> Watts Bar Nuclear Plant, Unit 2 NRC Docket No. 50-391

## Subject: Watts Bar Nuclear Plant (WBN) Unit 2 - Response to Requests for Additional Information (RAIs) Regarding Inadvertent ECCS Actuation Analysis, and Chemical & Volume Control System Malfunction Analysis

- 1. Proposed Markup to Unit 2 FSAR Incorporates Analysis for Inadvertent ECCS Actuation
- 2. Proposed Markup to Unit 2 FSAR Incorporates Analysis for Inadvertent CVCS Malfunction

Figure 15.2-42a Inadvertent Operation of the Emergency Core Cooling System -Nuclear Power and Core Average Temperature Response

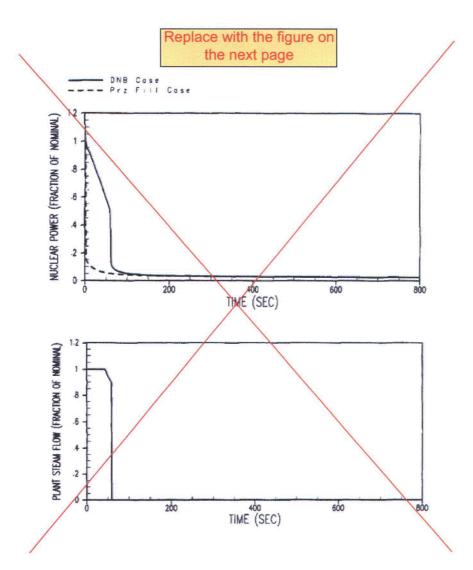
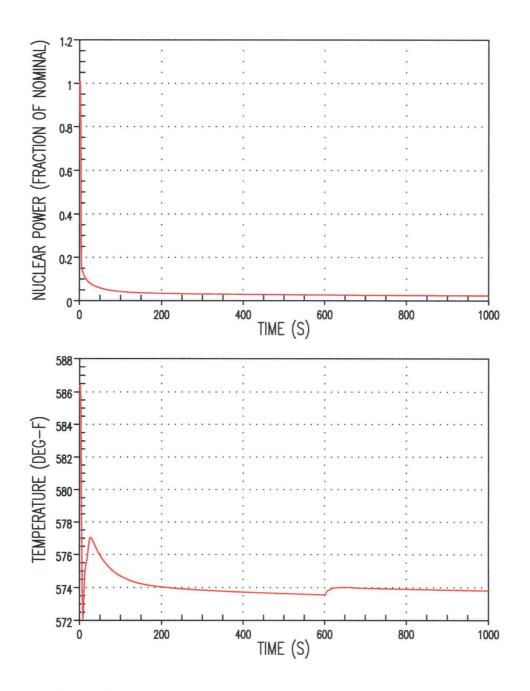
During the audit, TVA was asked to reanalyze the Inadvertent ECCS event to be consistent with the concerns documented in NRC Regulatory Issue Summary 2005-29.

To address this request, Westinghouse performed a review of the analysis presented in the licensing application and identified sources of margin. The original analysis modeled pressurizer backup heater actuation on high level deviation, which results in additional coolant heatup and expansion in the pressurizer. This control system function has been defeated for both Watts Bar units. The reanalysis reflects this change. Second, the original analysis modeled a bounding initial pressurizer level uncertainty. For the reanalysis, this uncertainty was reduced to the actual plant calculated pressurizer level uncertainty. Finally, the original analysis modeled a bounding ECCS flow rate. The reanalysis used a Unit 2 specific maximum ECCS flow rate, which is conservative but lower than what was used in the original analysis.

The results of the updated analysis demonstrate that the pressurizer reaches a peak water volume of 1,732 ft<sup>3</sup> at approximately 667 seconds, compared to the total pressurizer volume of 1,846 ft<sup>3</sup> (including the surge line volume). The pressurizer does not go water solid during the event, assuming operator action time at 10 minutes to terminate injection flow. Therefore, neither the pressurizer power-operated relief valves (PORVs) nor the pressurizer safeties open while a water-solid condition exists in the pressurizer and the non-escalation acceptance criterion is met.

The transient responses for the minimum DNBR and pressurizer filling cases are shown in Figures 15.2-42a through 15.2-42c. Table 15.2-1 shows the calculated sequence of events. 
for both the minimum DNBR case

WATTS BAR NUCLEAR PLANT FINAL SAFETY ANALYSIS REPORT CVCS MALFUNCTION NUCLEAR POWER VS. TIME FIGURE 15.2.15-1

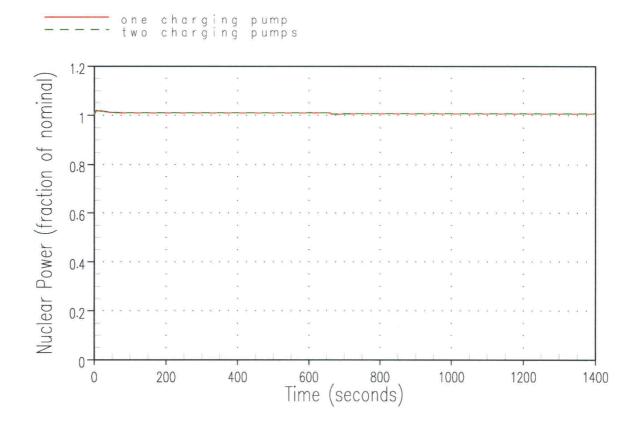
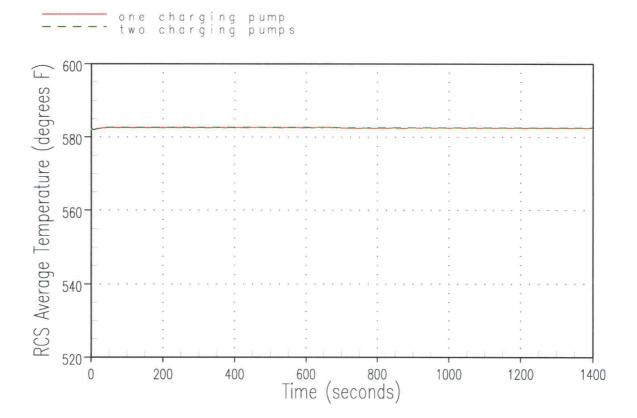
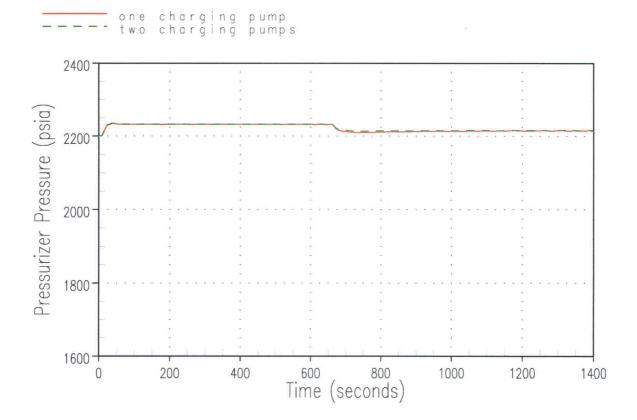
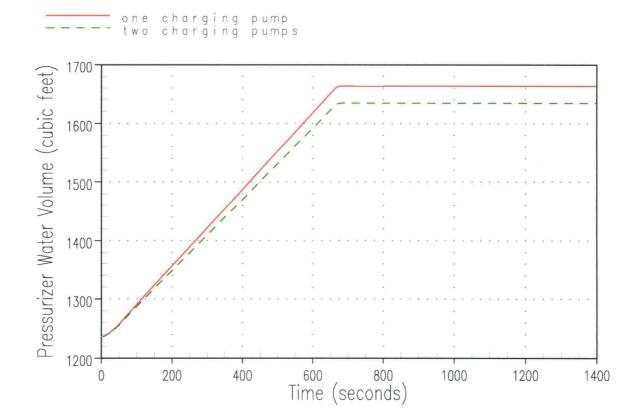
During the audit, TVA was asked to perform a CVCS malfunction analysis as required by NUREG-800, SRP 15.5.1-15.5.2.

Westinghouse performed the requested analysis. The analysis documents two CVCS Malfunction cases:

The pressurizer level increases as a result of the injected flow. In the case with one charging pump operating, the pressurizer reaches a peak water volume of 1,664 ft<sup>3</sup>, and in the case with two charging pumps operating, the peak pressurizer water volume is 1,635 ft<sup>3</sup>. Since the pressurizer does not fill in either case, there can be no water relief through either the PORVs or the Pressurizer Safety Relief Valves. The details of the assumptions and analysis results are provided in Attachment 2.

The transient responses for the limiting CVCS system malfunction cases are shown in Figures 15.2.15-1 through Figure 15.2.15-4. Table 15.2.15-1 shows the calculated sequence of events. In all the cases analyzed, core power and RCS temperatures remain relatively constant.

The pressurizer level increases as a result of the injected flow. In the case with one charging pump operating, the pressurizer reaches a peak water volume of 1664 ft<sup>3</sup>, and in the case with 2 charging pumps operating, the peak pressurizer water volume is 1635 ft<sup>3</sup>. Since the pressurizer does not fill in either case, there can be no water relief through either the PORVs or the PSRVs.
